Mattakeesett Ballfield Lighting

Addendum 1

This addendum contains the change to the electrical supply instructions and lighting specification.

Electrical Supply Instructions

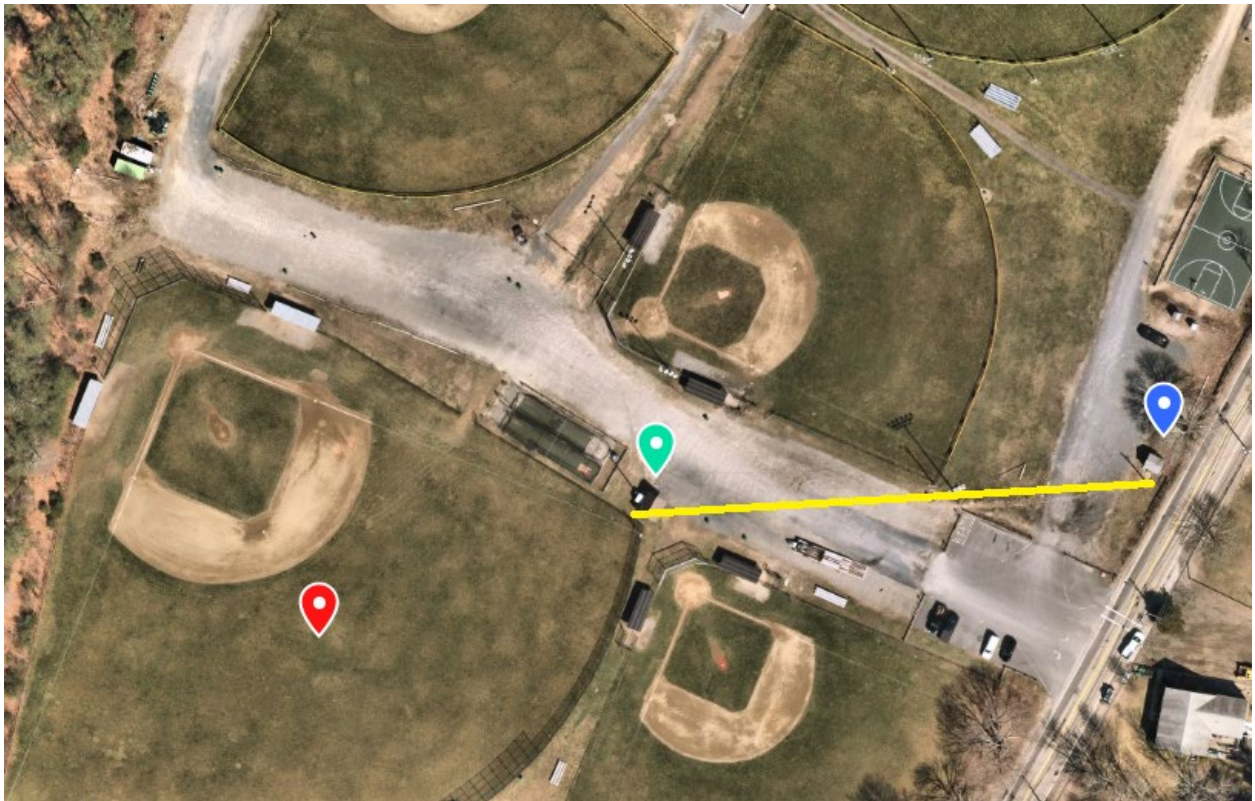
There is 480 volt 3 phase power available in the electrical shed shown as the blue location marker in image 1 below. The contractor will trench and provide a supply line from electrical shed to the shed shown as the green location marker. A sub panel will be installed at this point.
